Service Bulletin
No. MSB-E1-007

MANDATORY SERVICE BULLETIN

Approved Software and Hardware Versions of the E1 Engine Series.

Type: AE50R
Model(s): IAE50R-AA
Serial number(s): all

2.2. ILLUSTRATIONS

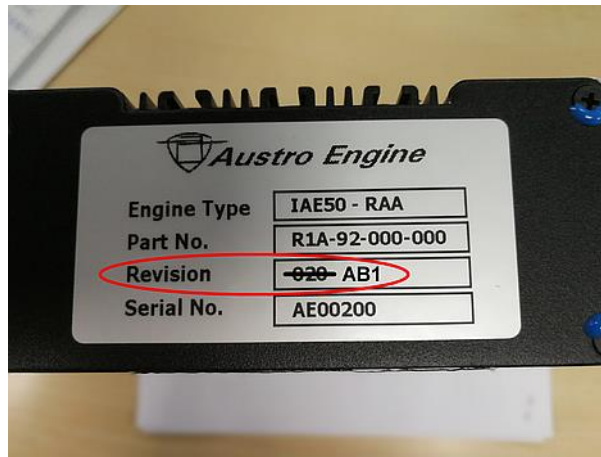
Previous Revision Scheme	New Revision Scheme	Comment
R1A-92-000-000- 020	R1A-92-000-000- AA1	HW is fully equivalent, can be updated to Rev " -AB1 " by SW-update

Original label:

Updated label:
